service bulletin

Bulletin No. 2002-12

High Idle RPM - 115 EFI (4-Stroke)

MERCURY/MARINER
2001 & 2002 Model Year
115 EFI (4-Stroke)
S/N OT178500 thru OT590369

- a** - Neutral Start Switch
b - Shift Slider

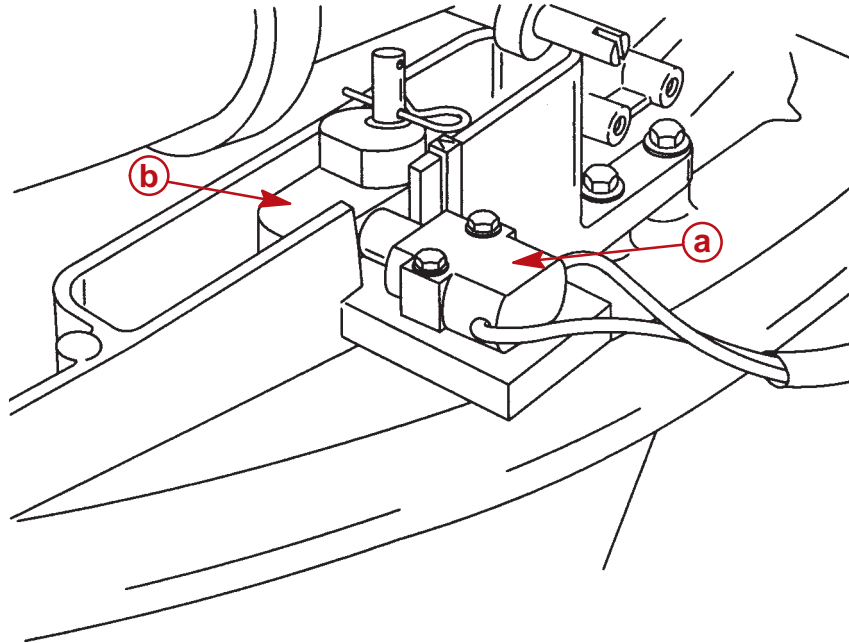
A small number of units within the above listed serial number range may experience a high idle condition. The high idle may be caused by a misalignment between the engine's neutral switch and shift slider.

1. Visually inspect that the neutral switch is depressed when the outboard is shifted into neutral and that the nose of the switch rides at approximately the vertical center of the shift slider.

2. After engine warm-up, the in-gear engine idle rpm should not significantly exceed 750 rpm. An in-gear idle rpm of approximately 900 rpm indicates a misaligned neutral switch. Refer to outboard service manual – “Electronic Fuel Injection” - “Troubleshooting and Diagnostics” - Diagnostic Code #28 “Incorrect Shift Position Switch”.
3. If it is determined that the engine’s neutral switch is misaligned, a Neutral Switch Shim Kit p/n 888417A1 should be installed as outlined in the installation instructions supplied with the kit.

Components Contained in Kit (888417A1)

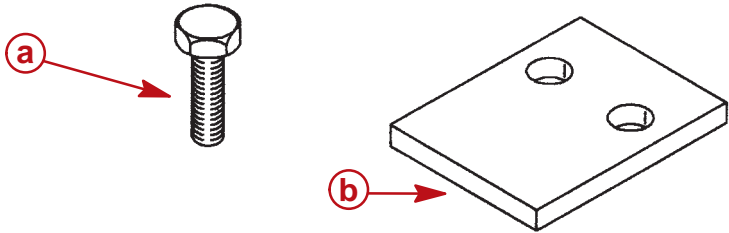
- a** - Screw M3.5 x 25 mm (2)
- b** - Shim
